APPEAL ATTACHMENT 'D'

Re: Project #3032857-LU

Correction Notice #1

Subject: Response to SDCI Review Comments
3410-3420 23rd Ave W, Seattle, WA
SDCI Project # 6694812-EX

Plate 1. City of Seattle street grading profile along east side of 23rd Avenue West

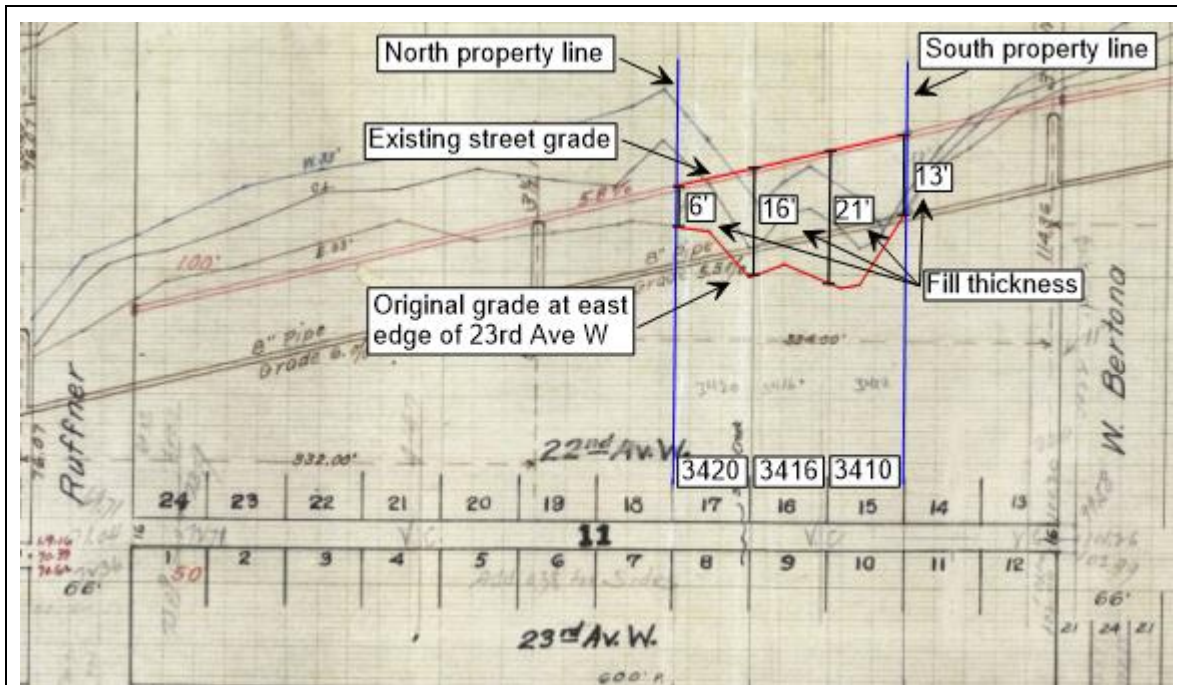
* Submit street grading profiles that are referenced in the geotechnical report to confirm that the western steep slopes (flanking the existing building) were created by previous grading activities.

We reviewed City of Seattle street grading profiles along the east side of 23rd Avenue West ROW (approximately the west boundary line of the subject site) to estimate the thickness of fill present at the site. The street grading profiles are shown on Plate 1 on page 2.

The grading profiles indicate that the existing street grade along the west site boundary was constructed by placing about 6 to 21 feet of fill as a result of past street grading. The fill thickness was about 13 to 21 feet for 3410 and 3416 – 23rd Avenue W parcels.

GENERALIZED
SUBSURFACE PROFILE
CROSS-SECTION A

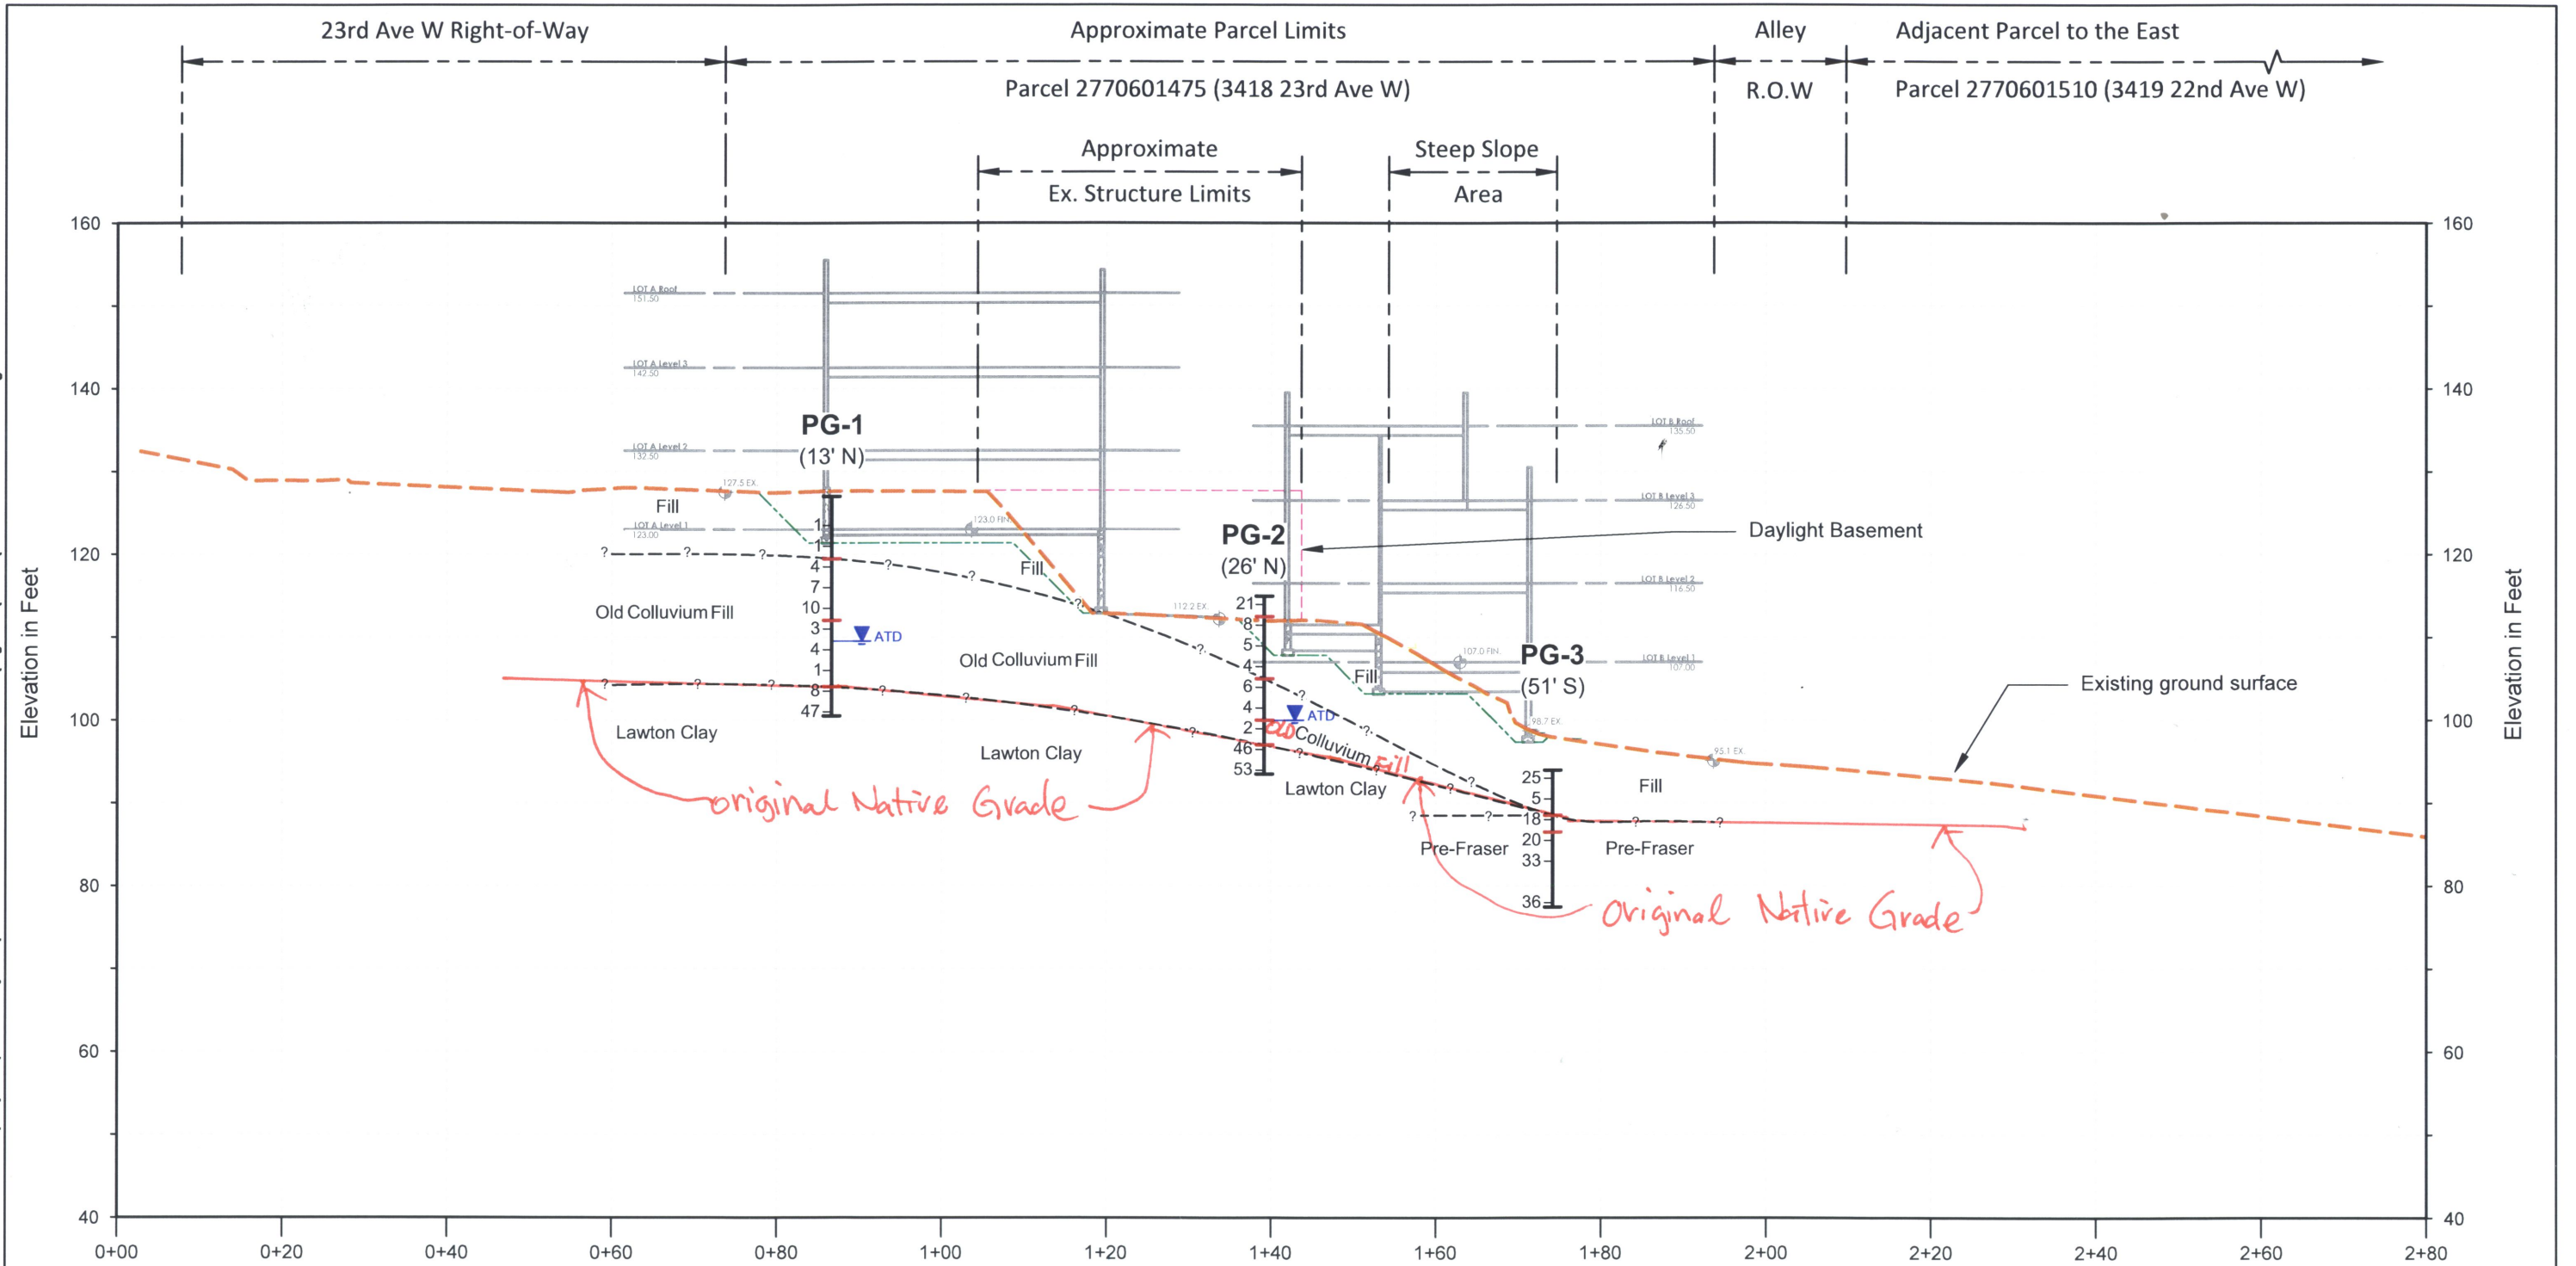
* Submit other information, such as additional subsurface data, to demonstrate that the eastern steep slope was created by previous legal grading activities, if possible.

We further reviewed subsurface data and soil samples encountered in our test borings. Based on our further review of the soil samples, existing street grading profiles, and the current site grade, it is our opinion that the colluvium unit describer in PG-1 and PG-2 is likely old colluvium fill placed during street grading and house development. The original grade below fill and colluvium fill (ie. Top of Lawton Clay and Pre-Fraser Deposits) is not a steep slope. We have updated our boring logs and subsurface profile to reflect this interpretation.
